The Foothills Development by Pino Dam, ZAP E-22

Re: Proposed Development by Pino Dam and Proposed Turnkey Agreement for Pino

Arroyo Improvements

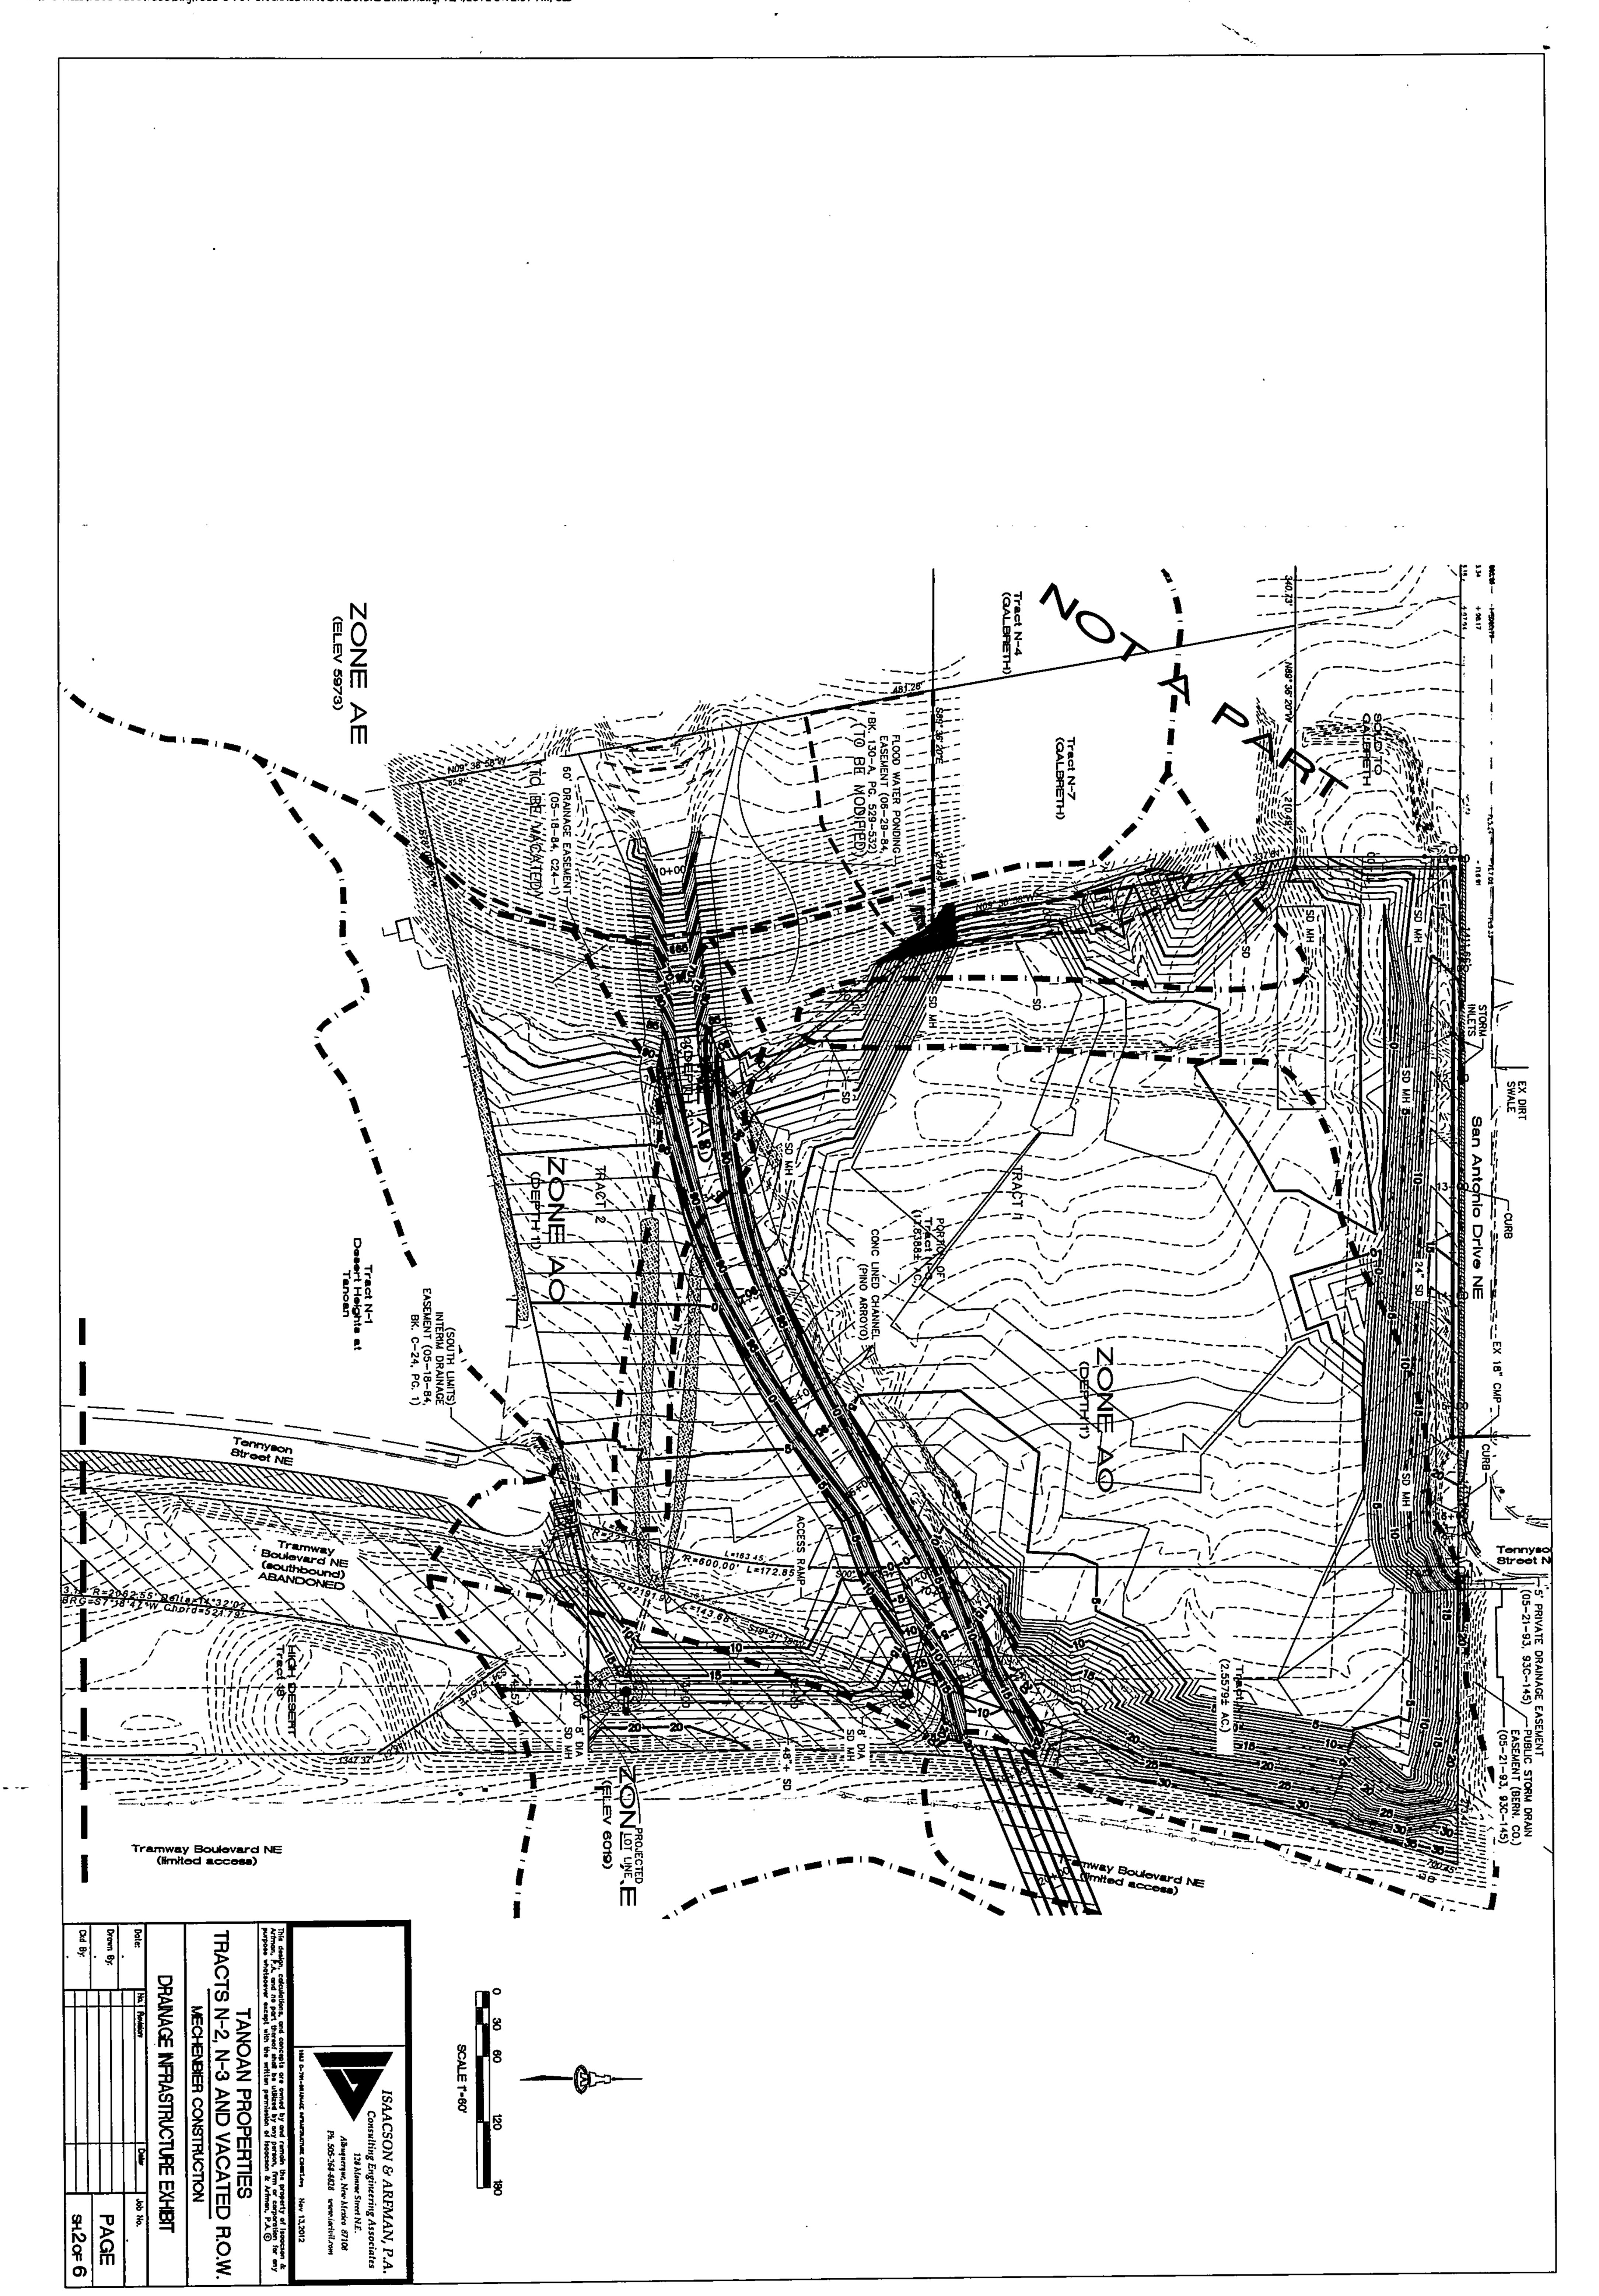
Tract N-3-A is east of the Pino Dam pool, south of San Antonio Drive and west of Tramway Boulevard (see Location Map). AMAFCA does not own the dam pool in fee but possesses three separate and overlapping drainage easements. Page 3 of the 2010 bulk land plat for the project area is attached for reference. It shows the easements. I have also included an enlargement of the easement descriptions.

*Easements 4, 6, 7, 8 and 9 were granted to AMAFCA. Only easements 6, 7 and 8 are on Tract N-3-A.
